26 May 2023

SH16 Brigham Creek to Kumeū Stage 2 - Notice of Requirement Further Section 92 Responses

Attachment 4 – SH16 Stage 2 – Wastewater Systems Remediation - Concept Plans

A plan showing the Indicative Strategic Network is provided below, with the following upgrades being included in the SATURN traffic model.

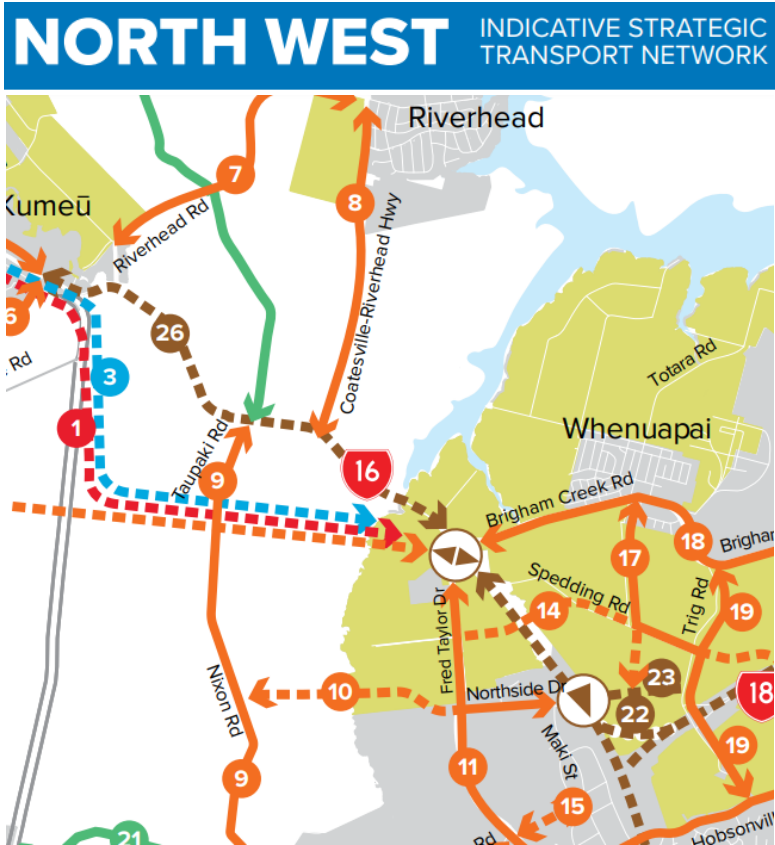
3. Please provide details of the “minimum network improvements” included in the 2026 TFUG Saturn Model, including what development is included for the surrounding area (Riverhead, Kumeū, Huapai).

The Do Minimum improvements are associated with the wider Northwest transport upgrades being considered by Te Tupu Ngātahi Supporting Growth Alliance (SGA) as included in the Indicative Strategic Transport network for the North West.

With the exception of the Alternative State Highway elements (1, 3 and 4) and Safe Network Programme (26), future roading connections associated with Redhills, Whenuapai, Westgate were included in the model. We note that the SH16 corridor (26) reflects the existing situation for the “Do Minimum” scenario and that Coatesville Riverhead Highway remains as a single traffic lane.

Redhills (2028/2038)

- 12-** New east west connections from Nelson Rd to Fred Taylor Drive
- 13-** New north south connection from the east-west connection (12) to Royal Road

Whenuapai (2028/2038)

- 14-** Spedding Road upgrade (in part)
- 17-** Upgrade and extension of Māmari Road from Northside Drive to Brigham Creek Road
- 18-** Upgrade Brigham Creek Road
- 19-** Upgrade Trig Road from Brigham Creek Road to Hobsonville Road

- 11-** Upgrade Fred Taylor Drive and Don Buck Road to Red Hills Road
- 15-** Dunlop Road extension from Fred Taylor Drive to Maki Street

- 22-** Direct State Highway connection between SH16-SH18, new shared path and interchange upgrades.

Attachment 2 – SH16 Stage 2 Process for Identifying and Remediating Affected Wastewater Systems

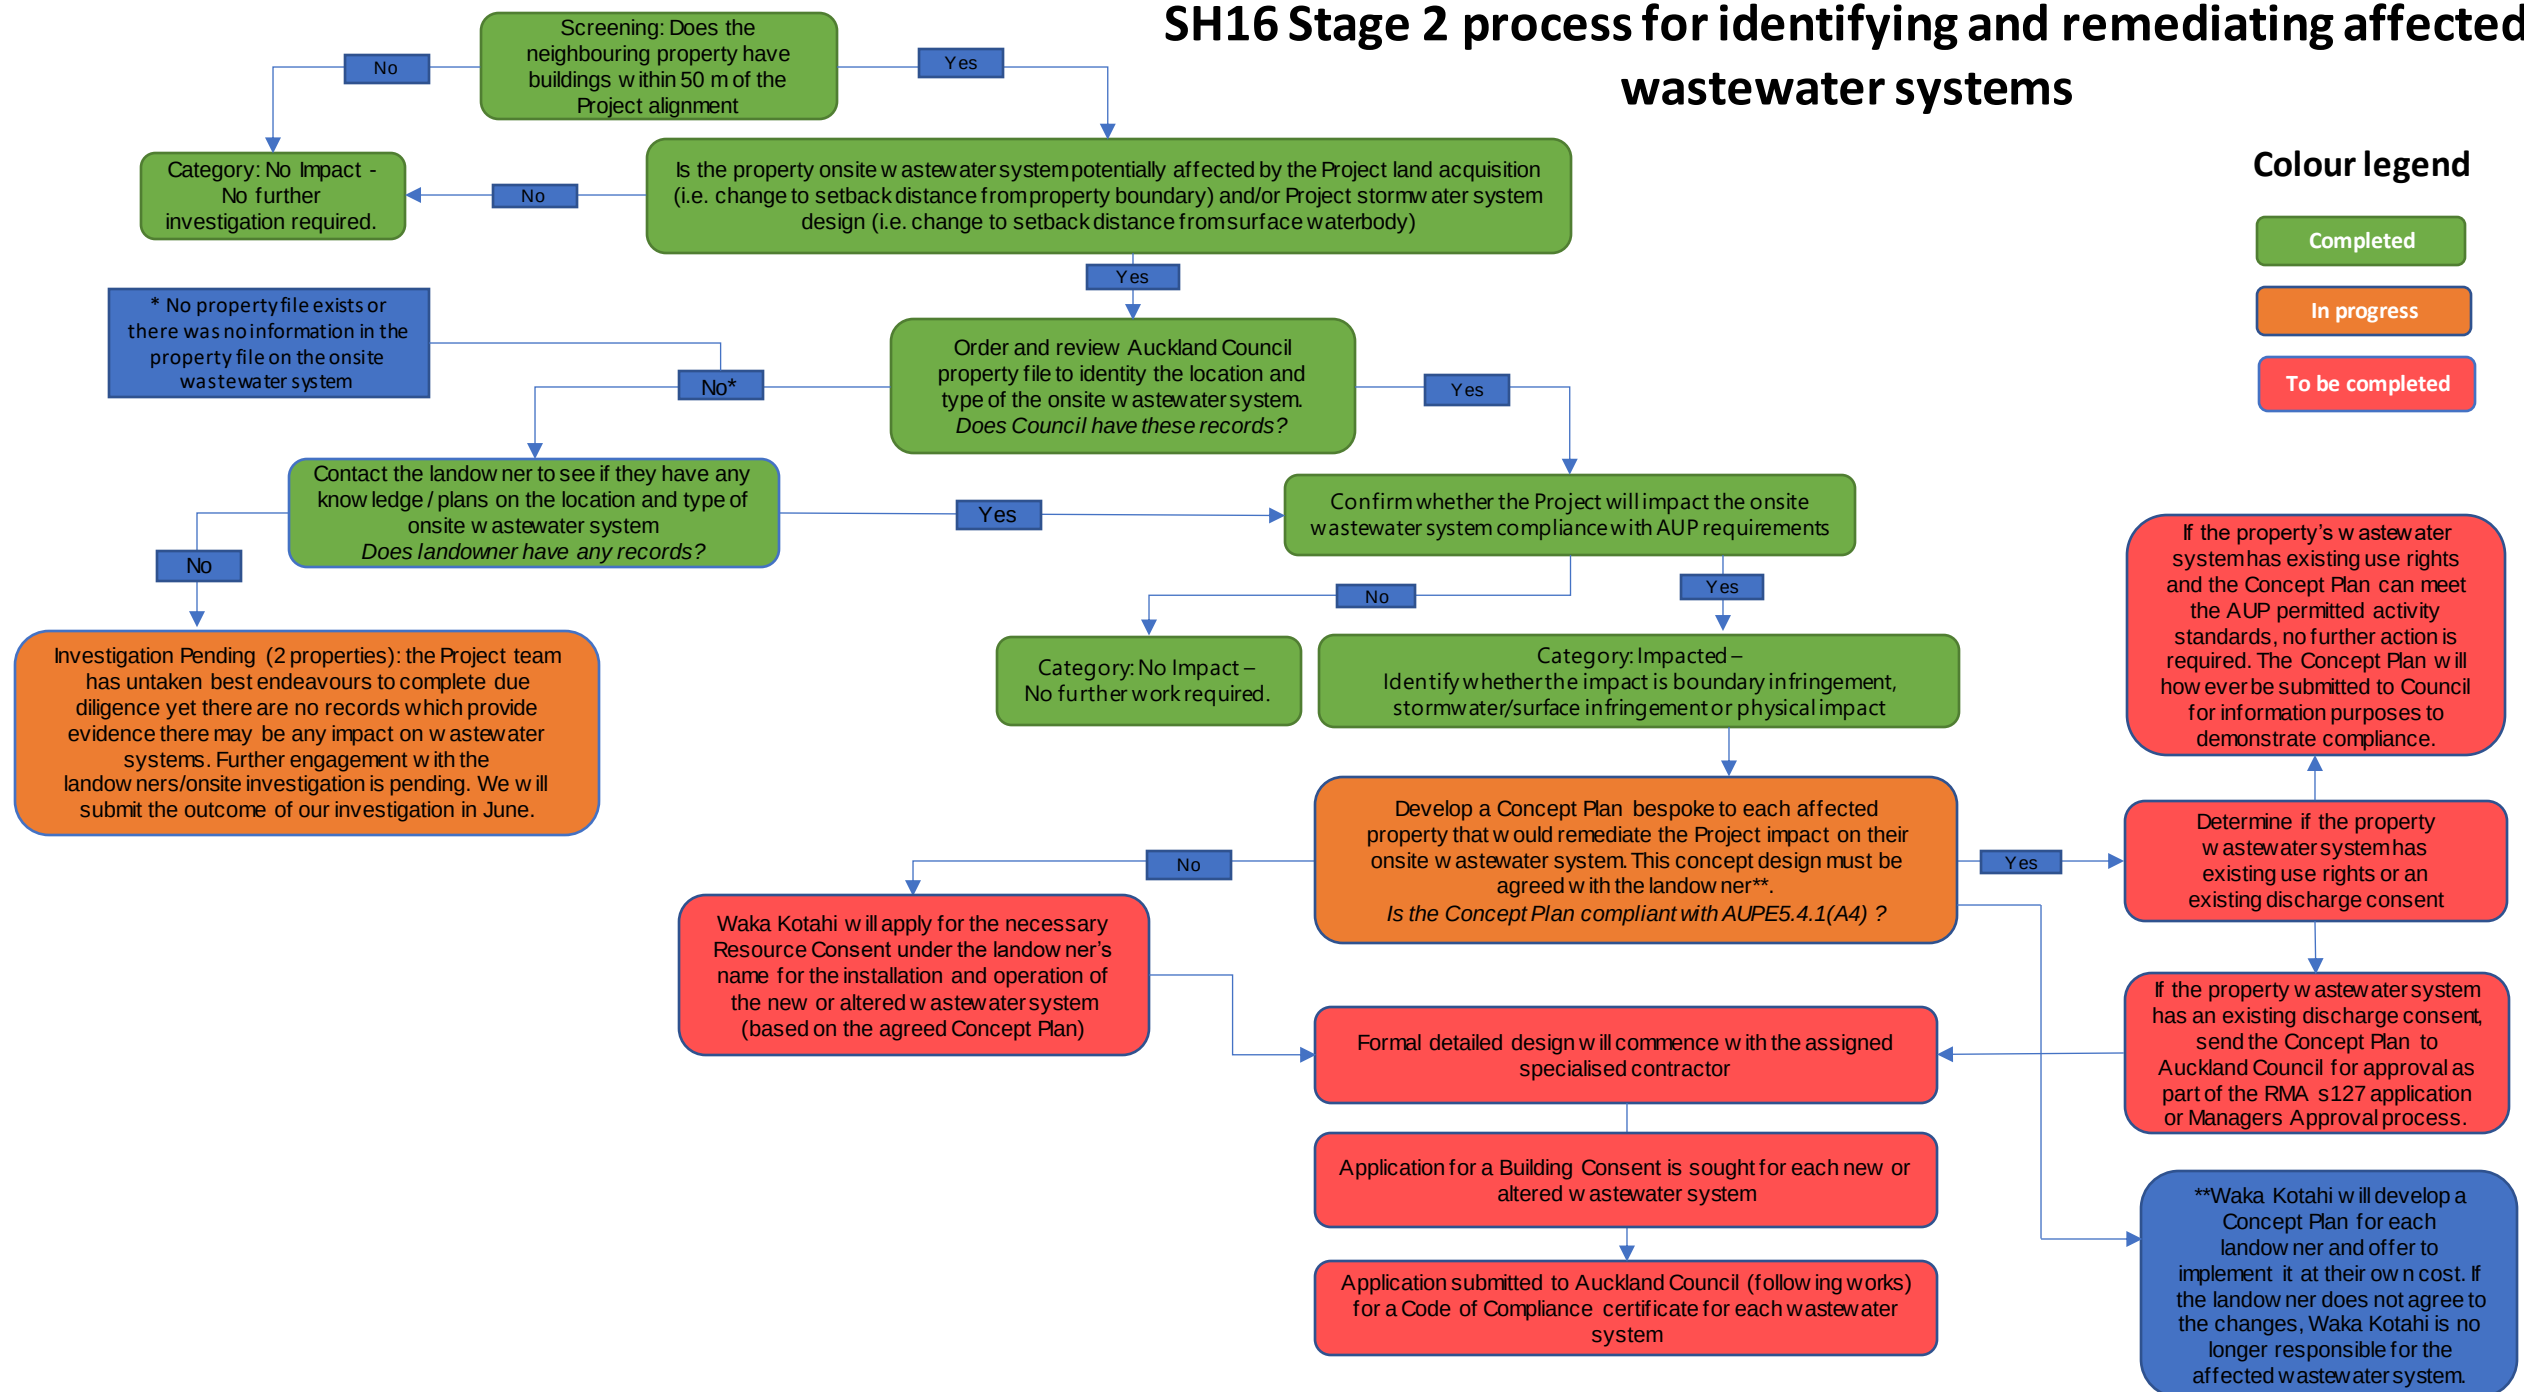
The overall general approach is generally okay. However, it lacks sufficient detail, timeframes and conditions. Five properties have been confirmed as being impacted. Impacted is specified as the functioning of the onsite wastewater system, or compliance with TP58. Impacted in terms of the wastewater rules of the AUP can take many forms. For example, a change in the site area to wastewater volume may be an impact, stormwater or groundwater changes may result in an impact, changes to soil buffer areas and so on. I would think we would like to review the results of the applicant's wastewater study at some stage to confirm if we are in agreement.

Please provide the onsite wastewater assessment for the impacted 59 properties for council review, or amend the proffered condition to address the above points.

As previously stated, an approach was adopted to screen all properties adjoining the Project alignment to identify whether the Project would directly impact existing wastewater systems or potentially make them non-compliant with Chapter E5 of the AUP:OP or any existing discharge consents. This process is set out in the diagram in Attachment 2 to this response and summarized as follows:

- Identify all habitable dwellings within 50m of the alignment (Note: the response to question 1 below provides the rationale for the 50m distance)
- For properties within 50m, confirm whether there is a land requirement for the Project which could potentially impact the site's wastewater system or reduce the separation distances and/or the site area to wastewater volume, making the wastewater system non-compliant with Chapter E5 of the AUP:OP and TP58.

- Properties with buildings located greater than 50m from the Project works or where no land requirement and no change to the stormwater system is proposed, no further investigation was undertaken as these properties were deemed to be unaffected by the Project, in terms of the wastewater system.
